Access Compliance Report

Public Rights-of-Way

Intersection ID: 27422	Main Street: BALLANTYNE COMMONS PY	Cross Street: STONEBRIAR DR	Location: SW
ADA ID: B0A39FA99CCF	Ramp Type: Perp	Initial Pass/Fail: Fail	Overall Compliance: No
Severity Score: 13.75			
Codes/Mitigation Info/Possible Solution		Field Measurements/Component Compliance

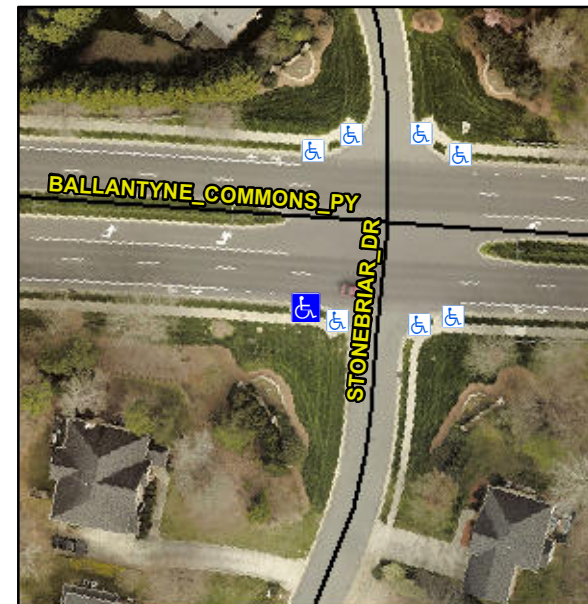
Not Found, R304.2.2

Compliance	Description	Data	Compliance	Description	Data
N/A	Ramp Length (in)	43.0	No	Ramp Slope (%)	9.6
Yes	Ramp Width (in)	51.0	Yes	Ramp XSlope (%)	2.3
N/A	Flare Type LT	N/A	N/A	Flare Type RT	N/A
N/A	Flare Slope LT (%)	N/A	N/A	Flare Slope RT (%)	N/A
N/A	Flare Traversable LT?	N/A	N/A	Flare Traversable RT?	N/A
N/A	Landing Length (in)	N/A	N/A	DWS Provided?	N/A
N/A	Landing Width (in)	N/A	N/A	DWS Contrast?	N/A
N/A	Landing Slope (%)	N/A	N/A	DWS Length (in)	N/A
N/A	Landing X Slope (%)	N/A	N/A	DWS Full Width?	N/A
N/A	Landing Curb? (Y/N)	N/A	N/A	DWS Offset (in)	N/A
N/A	Shared Landing?	N/A			
N/A	Gutter Ponding?	N/A	N/A	Gutter Slope (%)	N/A
N/A	Gutter Lip Ht (in)	N/A	N/A	Gutter X Slope (%)	N/A
N/A	Painted X Walk1?	No	N/A	Painted X Walk2?	N/A
	X Walk 1 Direction	To N		X Walk 2 Direction	N/A
N/A	X Walk 1 Width (in)	N/A	N/A	X Walk 2 Width (in)	N/A
	X Walk 1 Slope (%)	0.1		X Walk 2 Slope (%)	N/A
	X Walk 1 X Slope (%)	3.4		X Walk 2 X Slope (%)	N/A

Remove & Replace Entire Ramp.
